**MINUTES OF THE MEETING  
March 20, 2008**

**Seattle  
Design  
Commission**

**20 March 2008      Project: Capitol Hill Station ST University Link**

**Figure 7: Art piece**

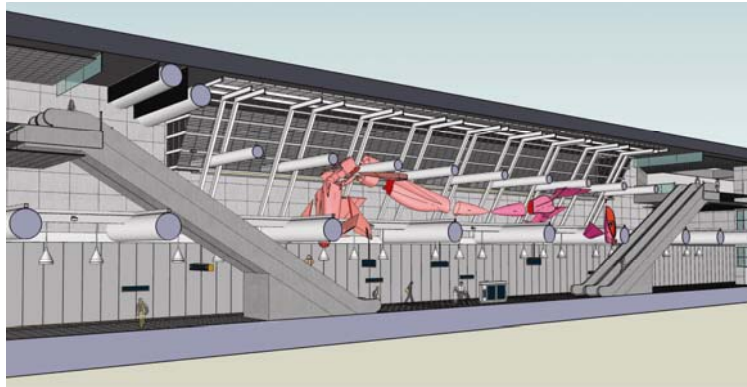
- The materials palette seems reserved and somewhat institutional and may benefit from a more dynamic color scheme.
- Some panel members expressed a concern for the use of warplanes in art piece in the context of a light rail station. While we appreciate the artist's intention of expressing fluid movement and natural forms, the relationship between natural form and a fighter plane as presented is questionable. A solution may be an artist statement prepared for the next presentation to clarify the appropriateness of the art in the station.

aesthetic interest. The piece gives grace and femininity to the strength and masculinity of the planes.

- Other ways planes penetrate architecture that is not so offensive?
  - Urge great care in emphasizing poetry of forms in people's minds. Notion of destruction is there in the fighter jets, but the entire form after deconstruction of the pieces is holistic. The piece is not meant to convey aggression.

- Chosen a provocative art piece. Planes may be appropriate with everything that is going on in area and the neighborhood.
- Concern over violent ramifications of art piece. Appreciate that the art seeks to connect important "Seattle qualities" of nature and technology into this piece, but question the use of a fighter jet as the manifestation of those ideas. Encourage further reflection on this, and preparation of an artist's statement for review next time.
